MFN 06-189

Subject: Response to Portion of RAI Letter Number 20 Related to ESBWR Design Certification Application – Seismic Design – RAI Numbers 2.5-1, 3.7-5, 3.7-7, 3.7-8, 3.7-11, 3.7-12, 3.7-25, 3.7-26, 3.7-29, 3.7-34, 3.7-52, and 3.7-55

**Response to Portion of NRC RAI Letter No. 20
Related to ESBWR Design Certification Application
Seismic Design**

**RAI Numbers 2.5-1, 3.7-5, 3.7-7, 3.7-8, 3.7-11, 3.7-12, 3.7-25, 3.7-26,
3.7-29, 3.7-34, 3.7-52, and 3.7-55**

Figure 2.5-1. ESBWR Horizontal SSE Design Ground Spectra at Foundation Level

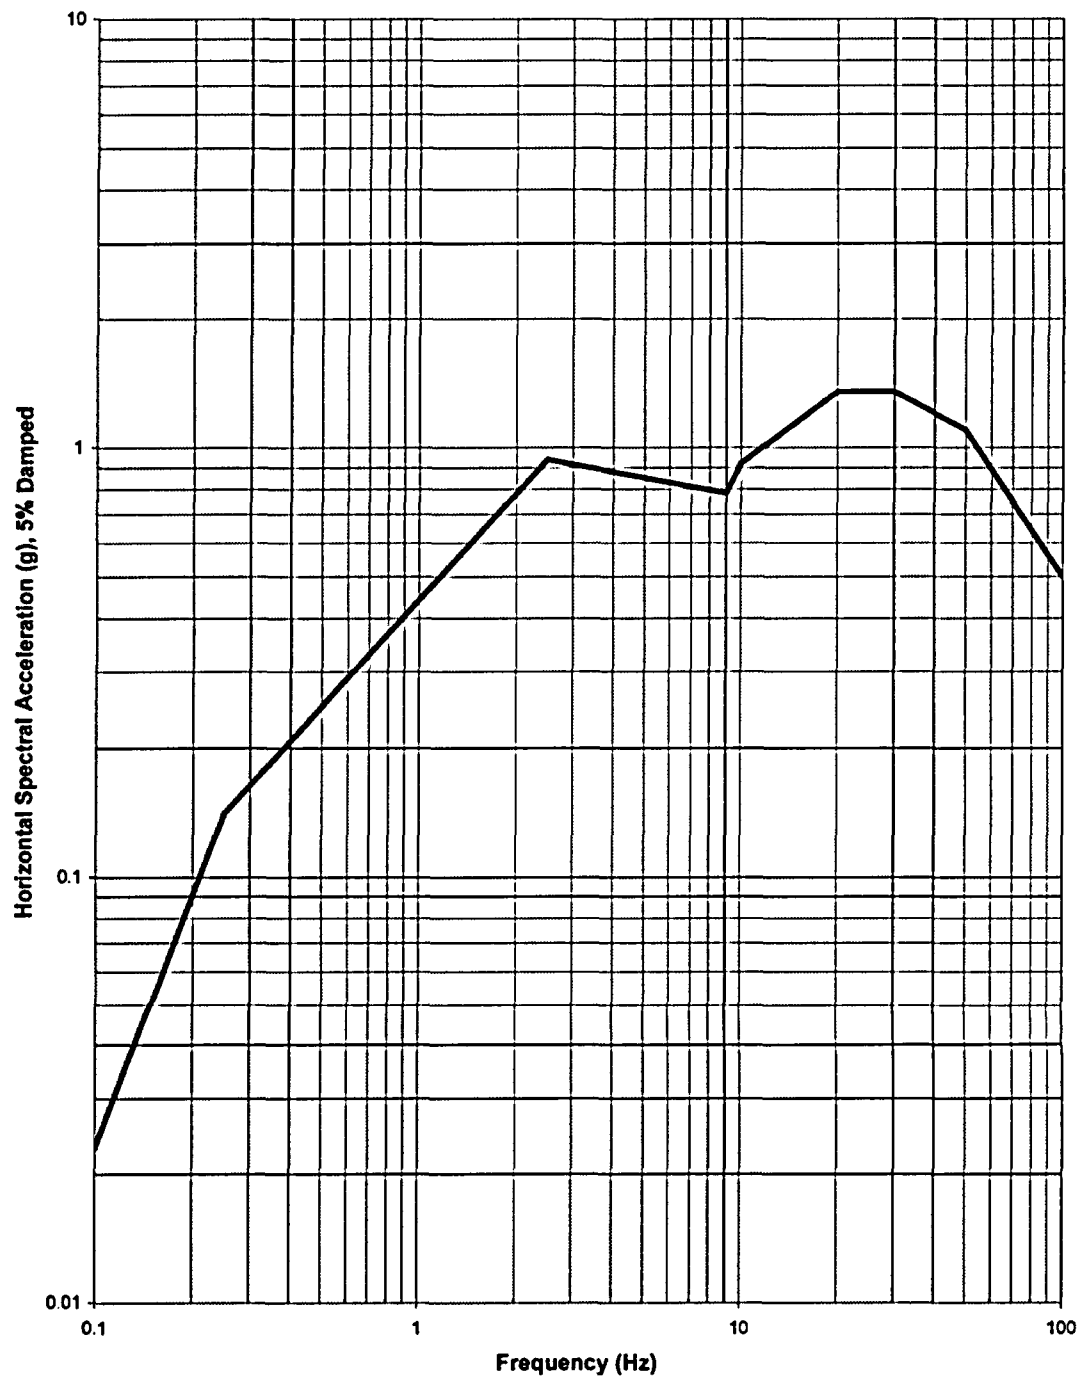
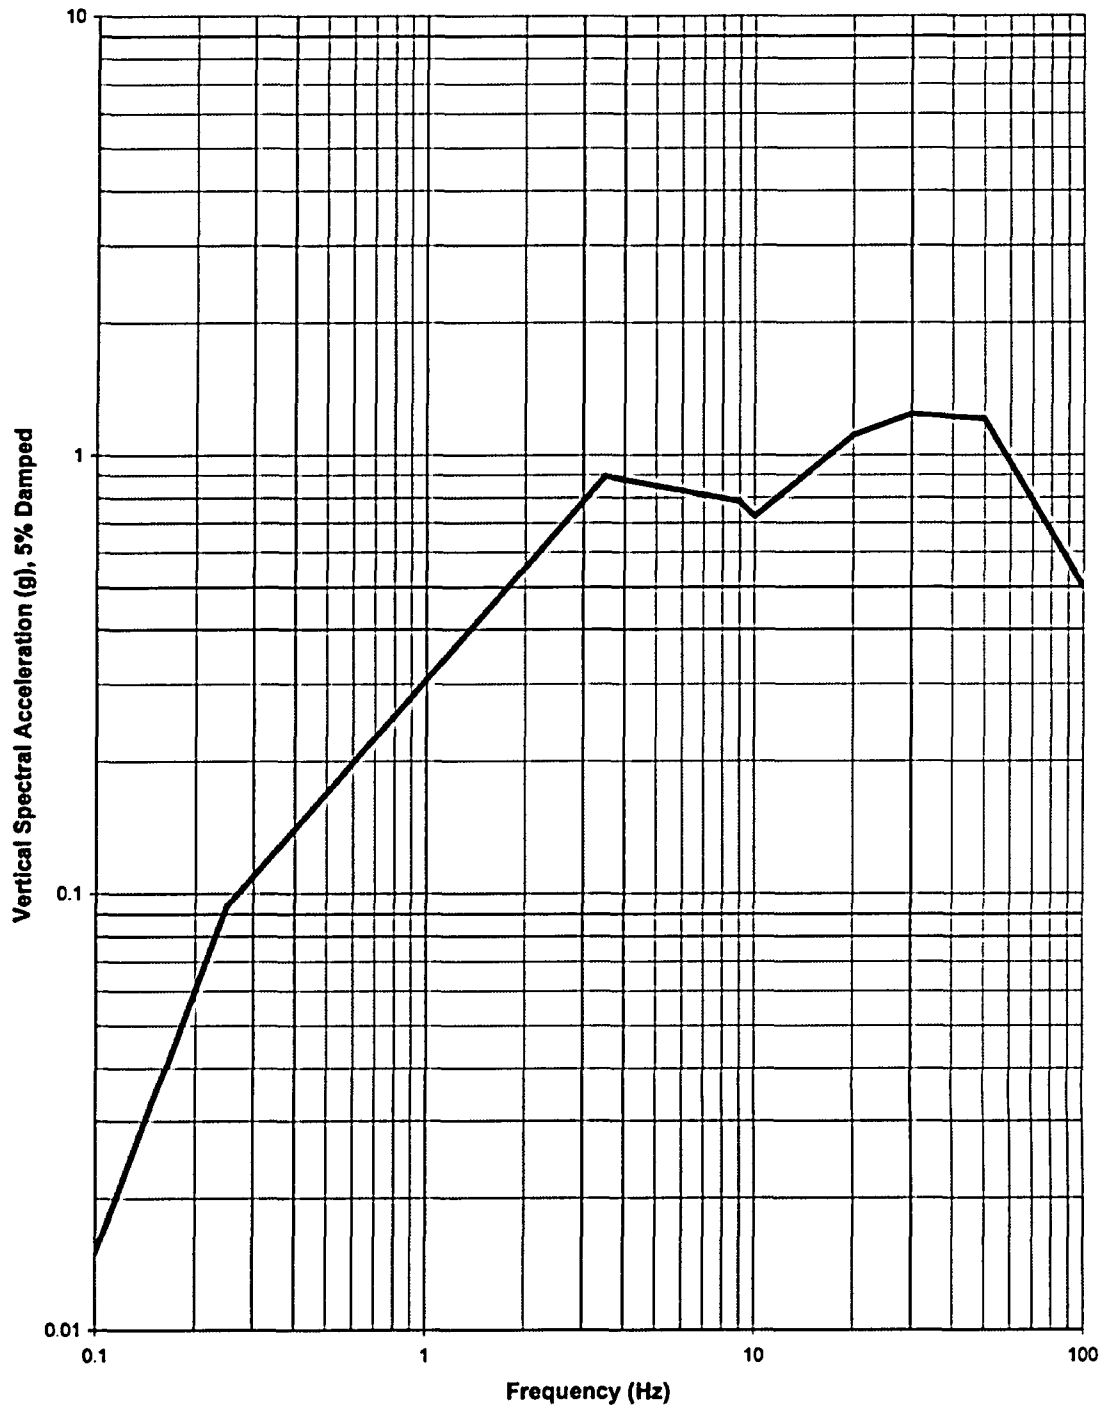
The North Anna early site permit (ESP) site-specific Safe Shutdown Earthquake (SSE) spectra shown in DCD Tier 2, Figures 2.5-1 and 2.5-2 (DCD Pages 2.5-13 and 2.5-14) is not the final SSE approved by the staff for the North Anna ESP site. The final North Anna SSE for the ESP site incorporated site-specific amplifications (based on the local rock and soil properties) of both the horizontal and vertical ground motions as determined from the North Anna site controlling earthquakes. Please update the North Anna ESP SSE or justify the use of the North Anna ESP that does not include the local site effects.

In DCD Section 3.7.1, the applicant stated that seismic design parameters (including seismic ground motion response spectra) considered for the ESBWR seismic design comprise two site conditions, generic and North Anna early site permit (ESP) sites. It is not clear from the descriptions provided in DCD Section 3.7.1 if the intent of the DCD is to show that (a) the design is appropriate for the North Anna site and any other generic site for which the RG 1.60 response spectrum is the appropriate SSE; or (b) if the design is to be considered appropriate for any site whose design response spectrum falls below the envelope of the RG 1.60 and North Anna design spectrum. The applicant also stated on Page 3.7-1, that the SSE is based upon an evaluation of the maximum seismic potential at a site. The DCD indicates that the results from the two separate ground motion sets are considered in the plant evaluations and development of enveloped responses. If the envelope spectrum were to be specified as the SSE, then a single set of time histories appropriate for this envelope spectrum would be used to generate enveloped responses. The staff requests the applicant clarify the definition of the SSE being used for the plant design, and also justify that the enveloped responses from load cases using multiple time histories (generic and North Anna) in fact leads to a conservative result of responses that would be obtained from a single ground motion time history (envelope of generic and North Anna ESP sites).

The spectra identified as “North Anna ESP – ESBWR CB Base” and “North Anna ESP – ESBWR RB/FB Base” in DCD Figures 2.5-1 and 2.5-2 are the high-frequency spectra computed exactly as they were for the North Anna Early Site Permit SSE but defined at control points corresponding to rock outcrop at the horizons of the control building and reactor/fuel building bases. These spectra are based on the same best estimate subsurface material properties model as the SSE at its higher control point at the top of competent rock. The same local site effects are included in each of these spectra.

DCD Tier 2 Table 2.0-1, Section 2.5.2, Figure 2.5-1, Figure 2.5-2, and Section 3.7.5.1(1) will be revised in the next update as noted in the attached markups. Similar changes will be made to DCD Tier 1 Table 5.1-1, Figure 5.1-1 and Figure 5.1-2 in the next update as noted in the attached markups.
